MISSISSIPPI RIVER-GULF OUTLET, LOUISIANA

GENERAL DESIGN MEMORANDUM NO. 2
SUPPLEMENT NO. 4
FORESHORE PROTECTION

SUBJECT: Mississippi River - Gulf Outlet, Louisiana, General Design
Memorandum No. 2, Supplement No. 4, Foreshore Protection

MISSISSIPPI RIVER - GULF OUTLET
NORTH BANK
(CITRUS BACK LEVEL)
FORESHORE DIKE
CONSTRUCTION PLAN

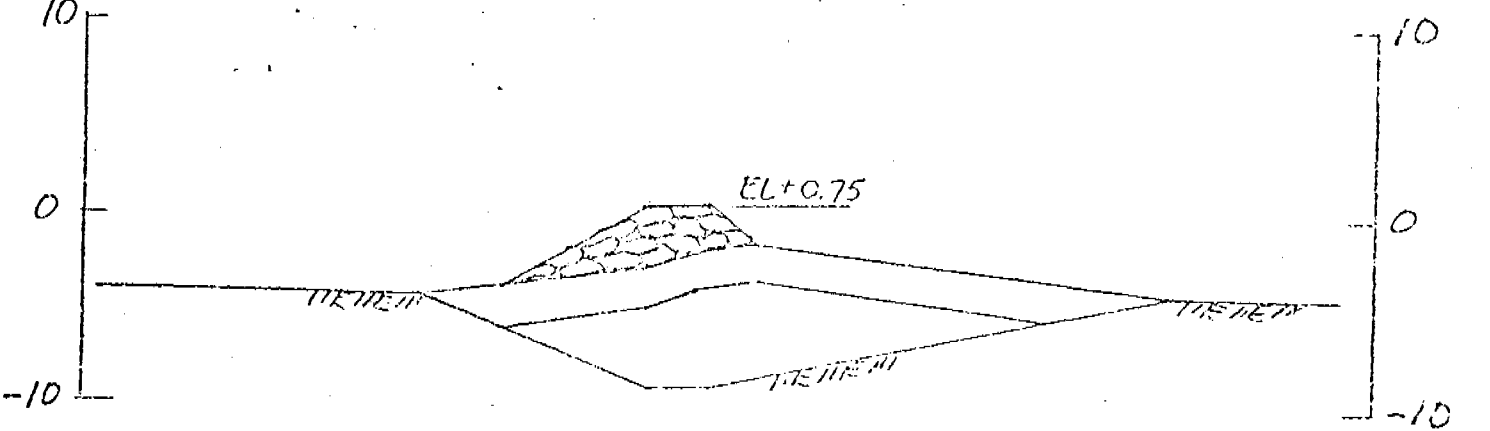
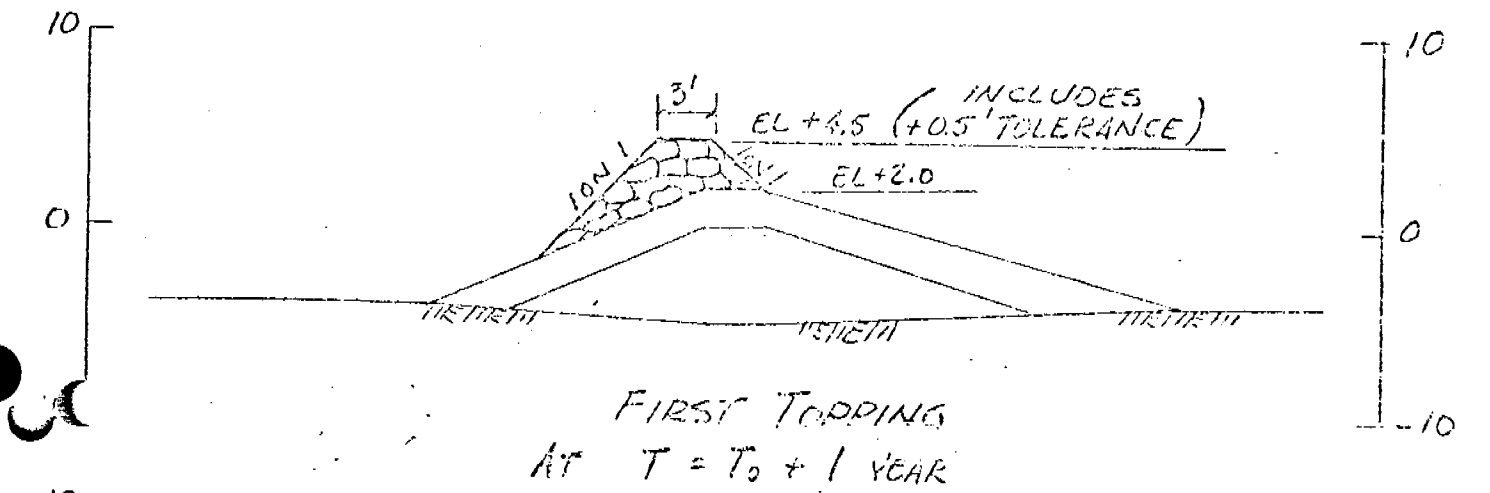
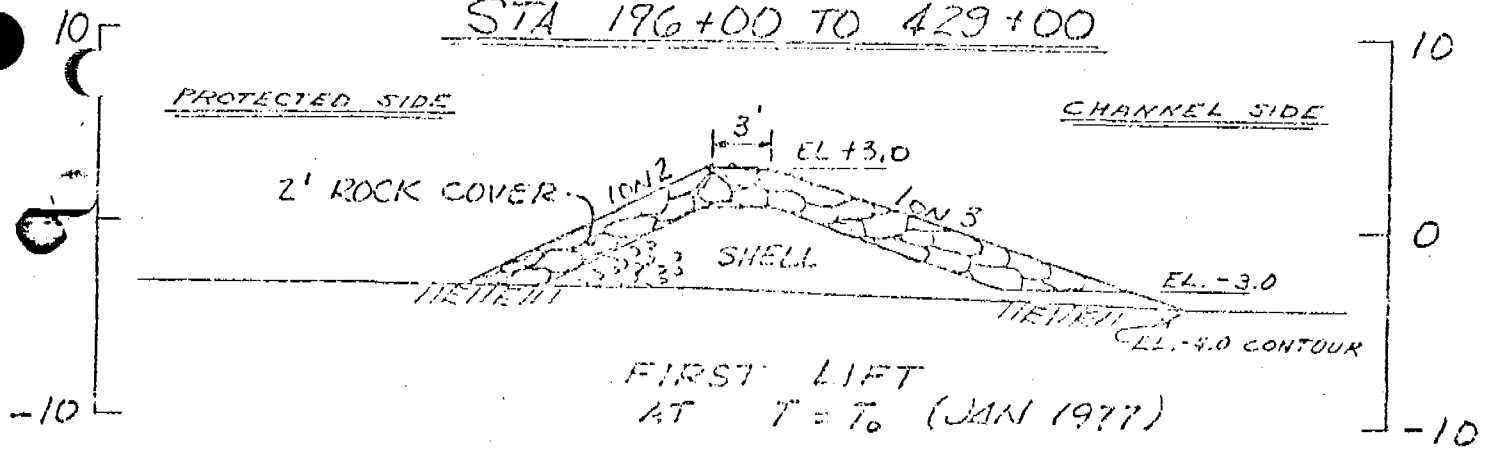
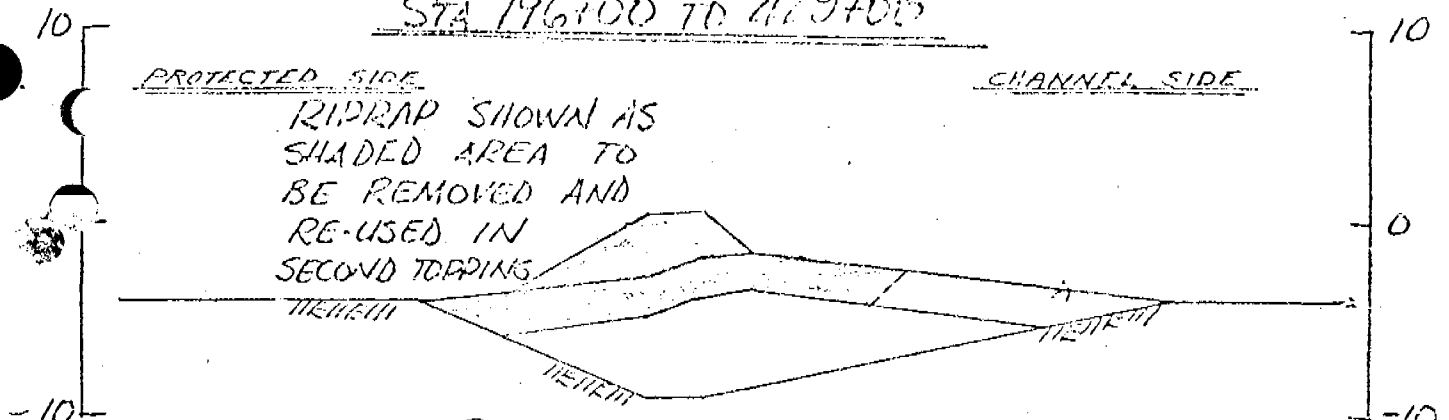
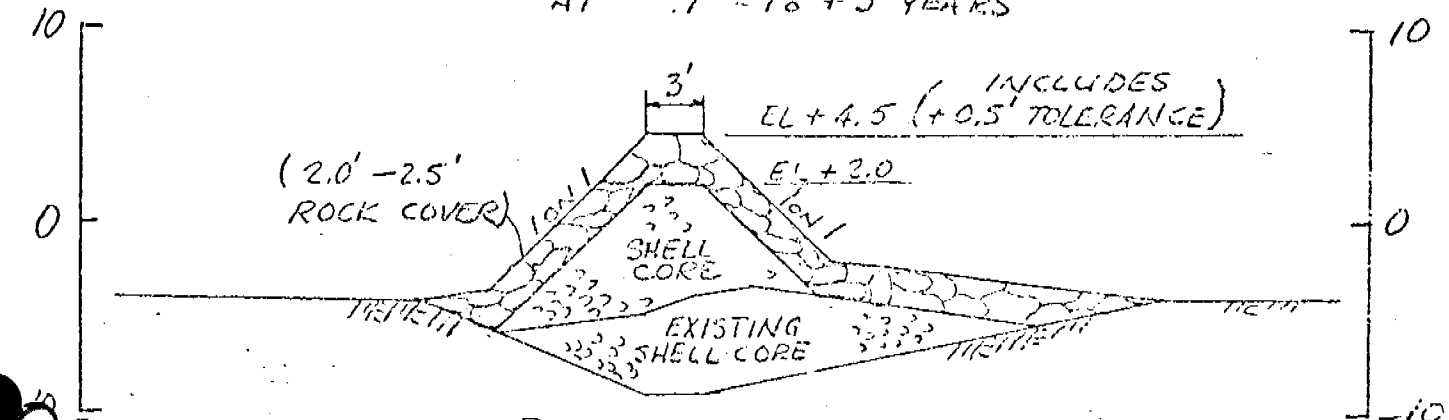
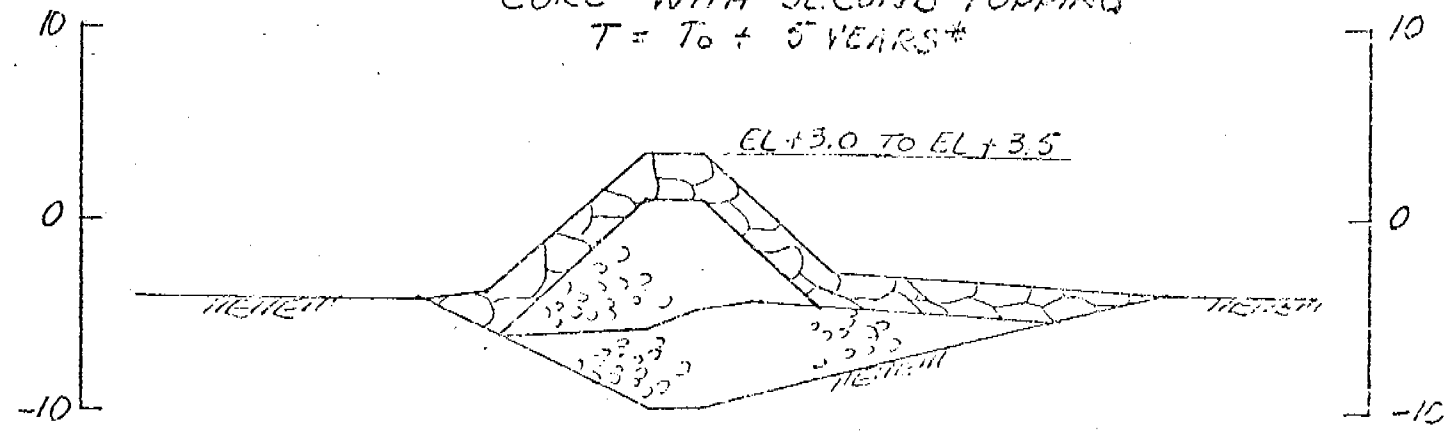
b. Construction sequence. As a result of the observed settlement that occurred subsequent to the foreshore dike first lift construction, a new settlement and stability analyses were performed. Based on those analyses, it was determined that only one topping, as presented in the subject general design memorandum supplement, would not be sufficient. The recommended foreshore dike construction sequence consists of a first lift with two subsequent toppings. In order to minimize dike settlement, prior to the second topping it will be necessary to remove a portion of the stone that was placed during the first lift and first topping, and replace it with shell. The complete construction plan is presented as inclosure 1. Stability analyses are presented as inclosure 4.

Note:
 Sections plotted are not to scale.
 Elevations are in feet and refer to mean sea level.
 This plate revised in accordance with LMVD comments,
 1st Ind., Par. 3.

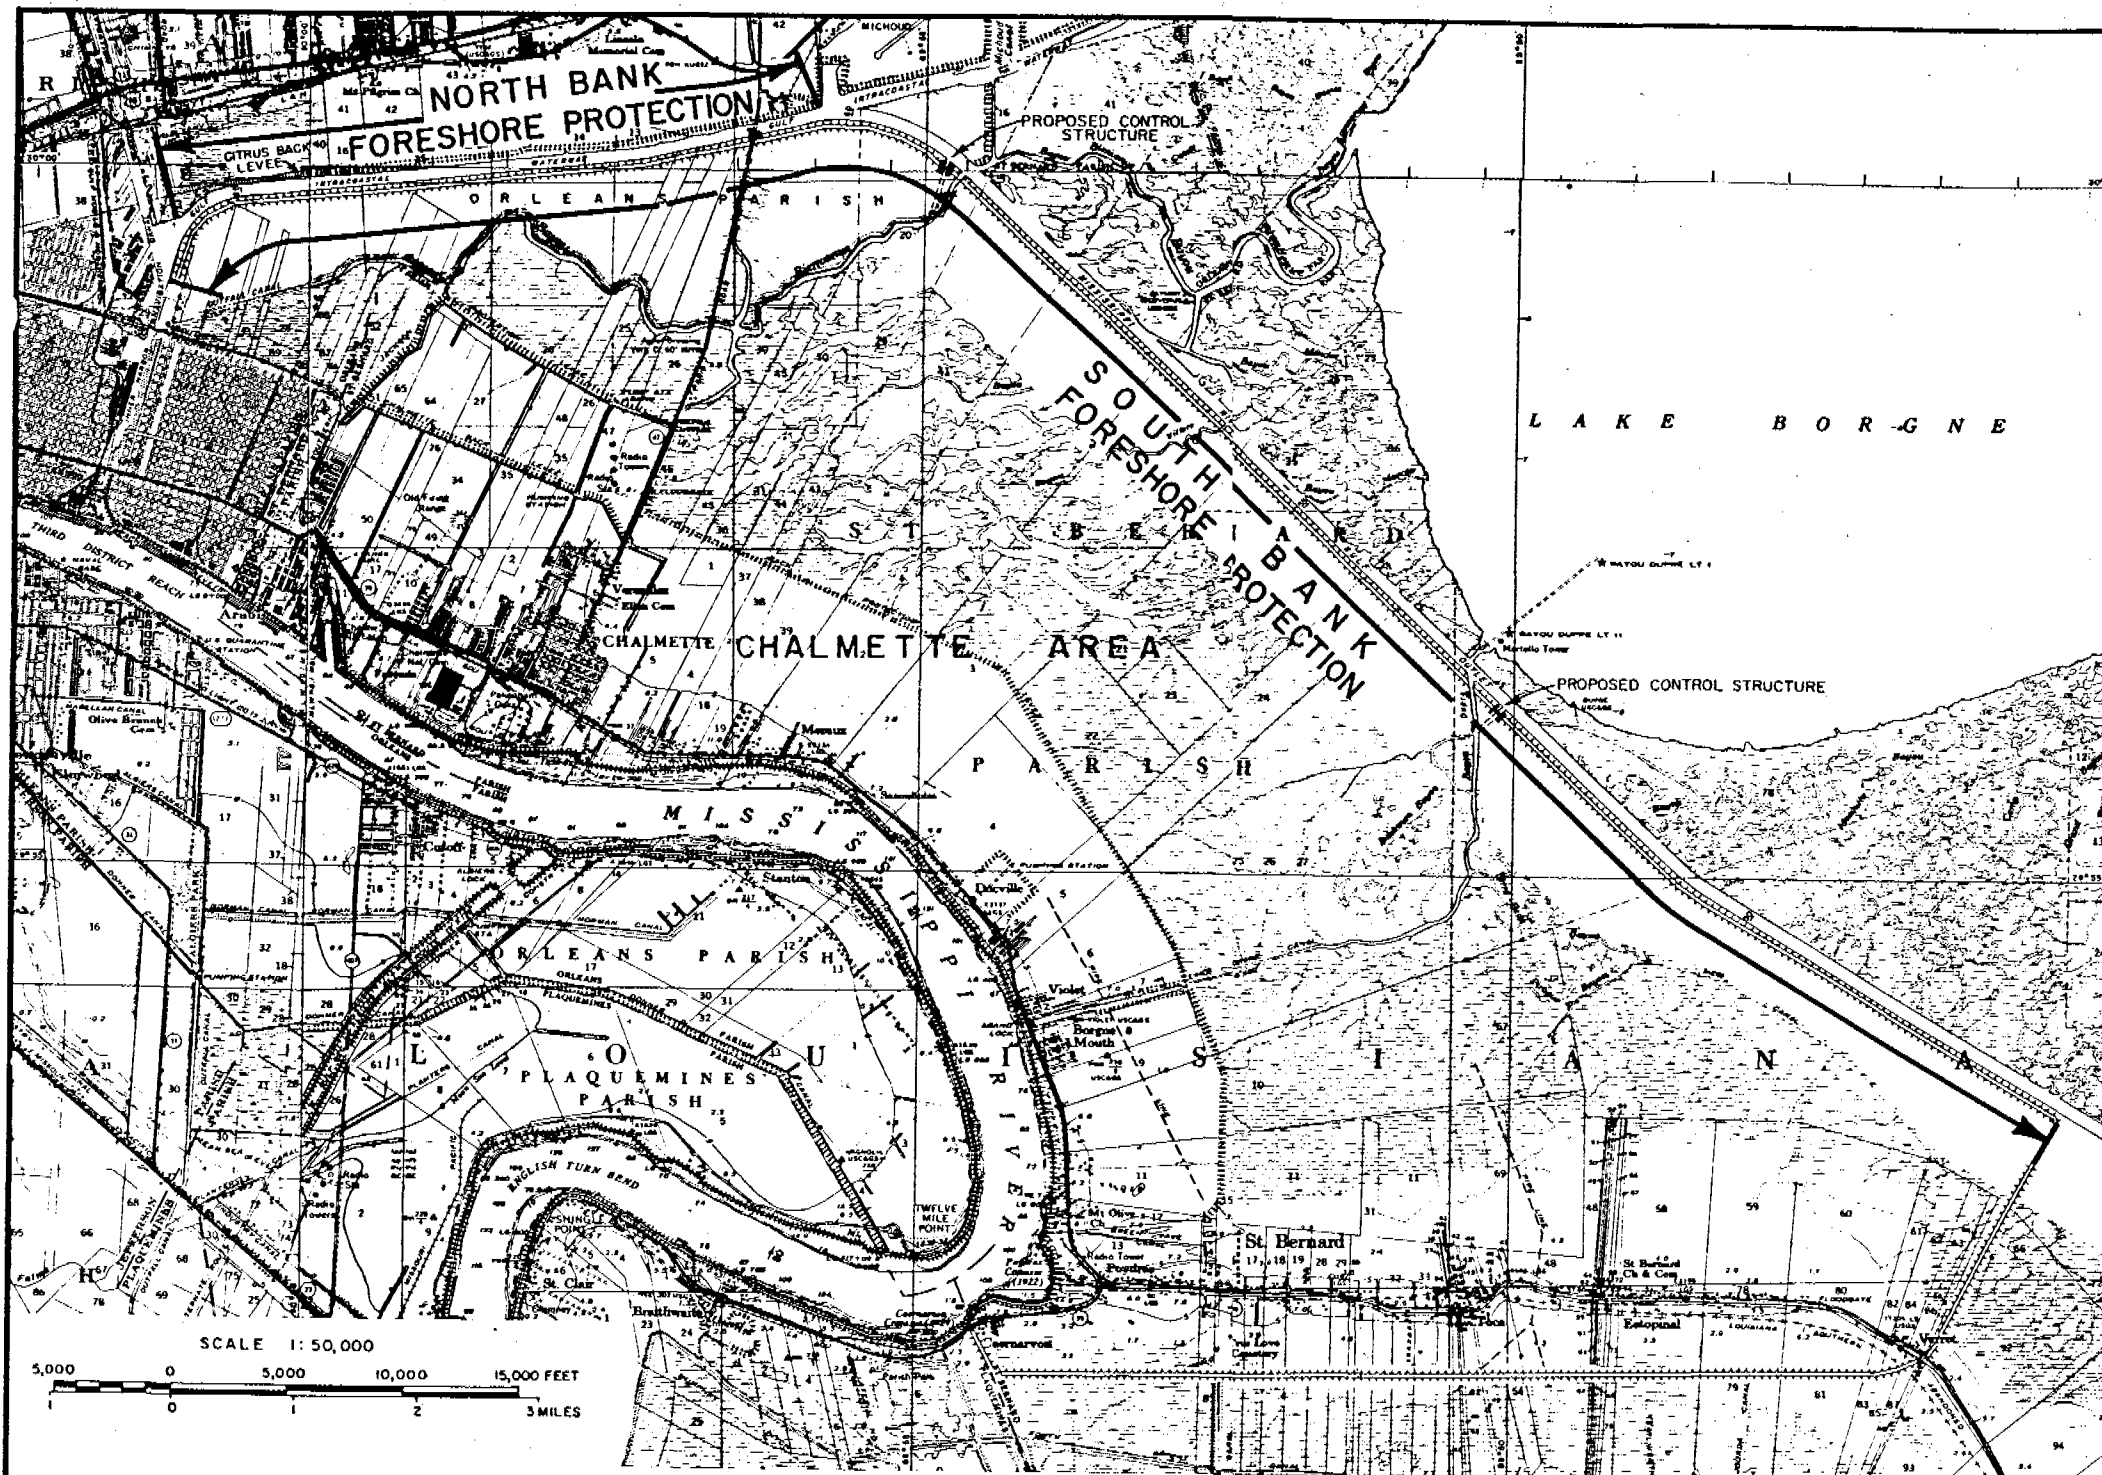
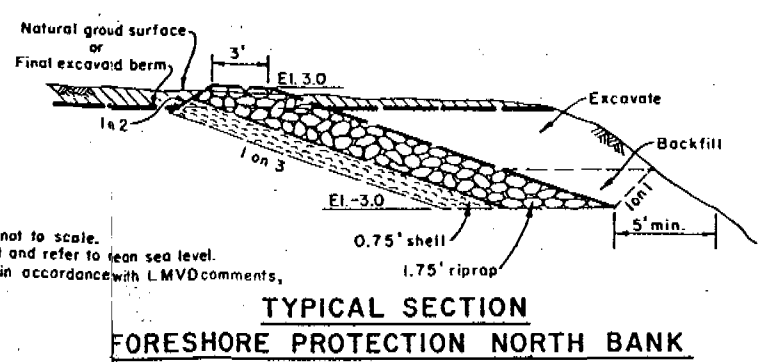
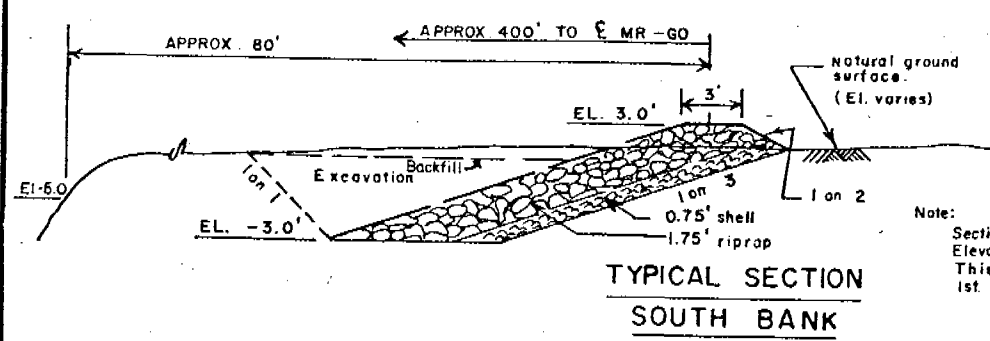
2. Plate 2. a. The top of the foreshore protection on the south bank is indicated to be located 750 feet from the centerline of the MR-GO. This distance agrees with that shown in GDM No. 3, Chalmette Area Plan, and presumably was based on conditions with the present 500-foot bottom width channel. If the current study of channel size results in the Gulf Outlet channel being enlarged to 50' x 750' and the GIWW portion of the channel is widened entirely on the south side, the adjacent Chalmette Area levee in this reach will have to be moved at least 250 feet farther from the existing centerline of the channel. The subject supplement should indicate what revisions in location of the protection are anticipated if the channel is widened.

2. Plate 2 of the subject supplement No. 4 has been revised to show the new typical section for the foreshore protection along the south bank and is inclosed (incl 2) herewith for inclusion in the memorandum.
